## SERVICE BULLETIN

ENGINE - FUEL AND CONTROL - TO PROVIDE A NEW ELECTRONIC ENGINE CONTROL (EEC) WITH THE  
SCN12B SOFTWARE CONFIGURATION - CATEGORY CODE 4 - MOD.ENG-73-0044

# V2500-ENG-73-0044

## Engine Fuel and Control - EEC150-1 Electronic Engine Control - Incorporation of New Software Configuration

Location of Electronic Engine Control (EEC)  
Fig.1

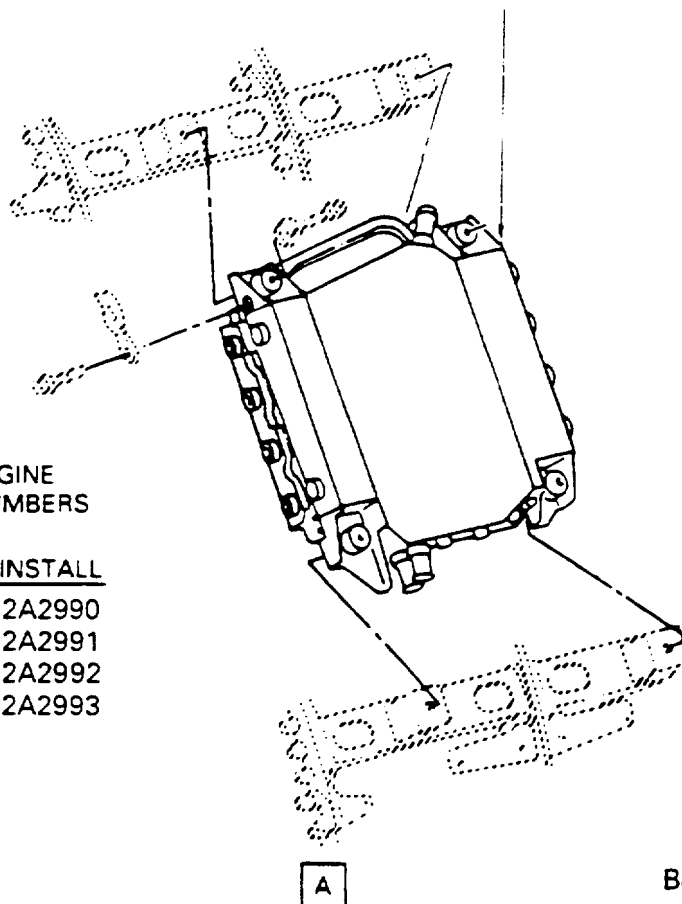
- (1) Remove the 2A2690, 2A2691, 2A2692 or 2A2757 Electronic Engine Control by the approved procedure given in Reference (3), Chapter/Section 73-22-34, Removal/Installation. Refer to Figure 1.

- (1) Install the 2A2990, 2A2991, 2A2992, or 2A2993 Electronic Engine Control (1 off) by the approved procedure given in Reference (3), Chapter/Section 73-22-34, Removal/Installation. See Figure 1.

REMOVE THE APPLICABLE PART NUMBER\*  
ELECTRONIC ENGINE CONTROL, DO A  
MODIFICATION, IDENTIFY AND INSTALL  
THE APPLICABLE PART NUMBER\*  
(1 Off)

Location of ACC Front Duct Cover Assembly  
Fig.2

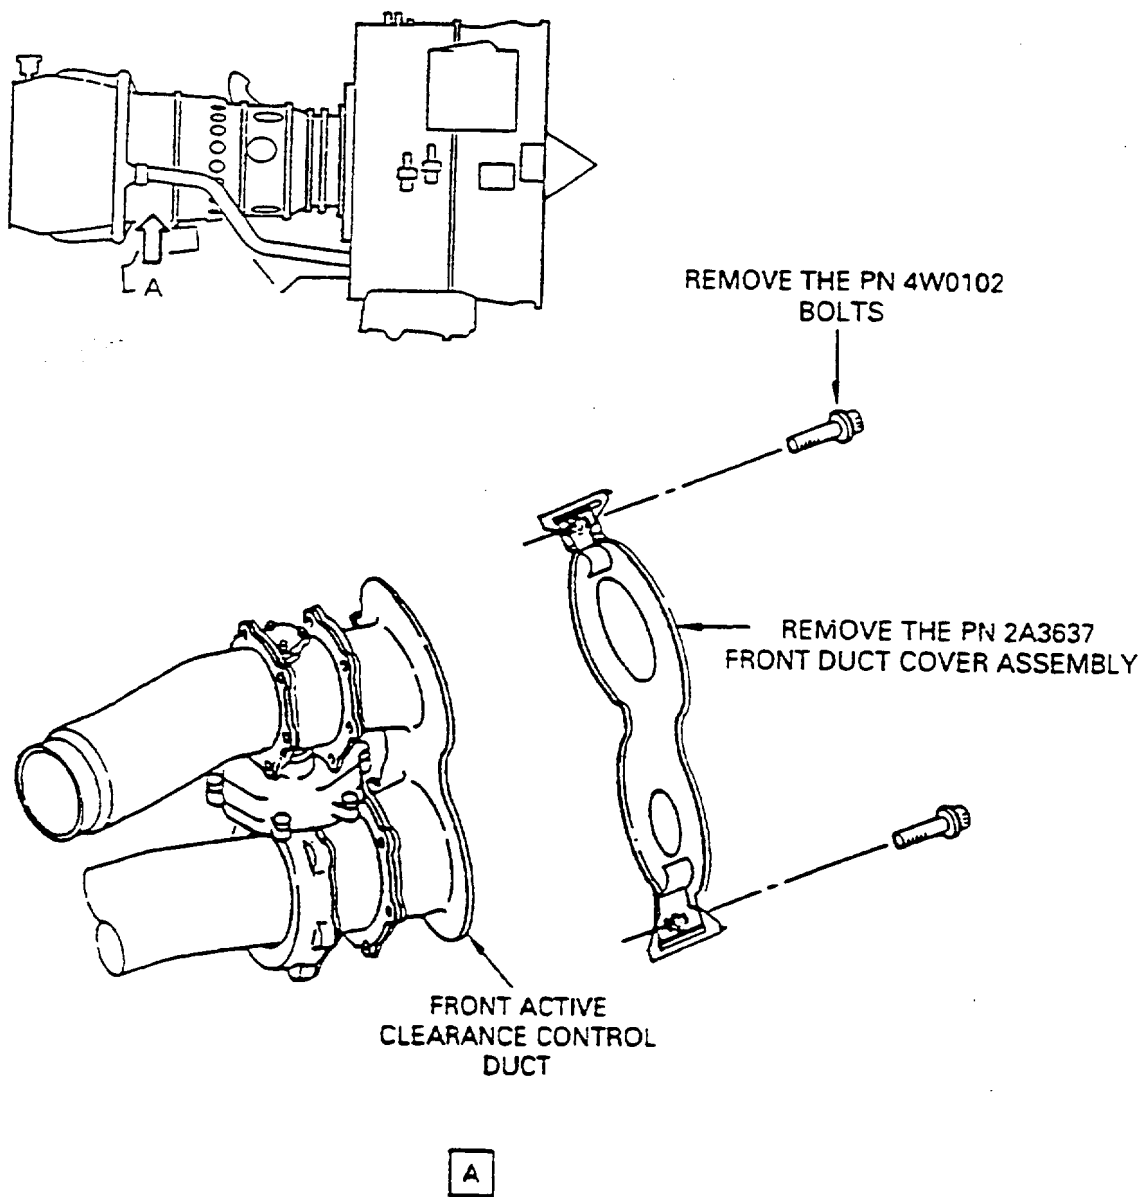
- (a) Send the Electronic Engine Control to the approved vendor to be modified. See Figure 1.
- (2) Remove the Active Clearance Control (ACC) Front Duct Cover Assembly. Refer to Reference (1) and Figure 2.
  - (a) Locate the Front ACC Duct.
  - (b) Remove the two 4W0102 Bolts from the Front Duct Cover Assembly.
  - (c) Remove the 2A3637 Front Duct Cover Assembly.

NOTE: When you incorporate this Service Bulletin with the new SCN12B software logic, the Front Duct Cover Assembly given in Reference (1) must be removed.
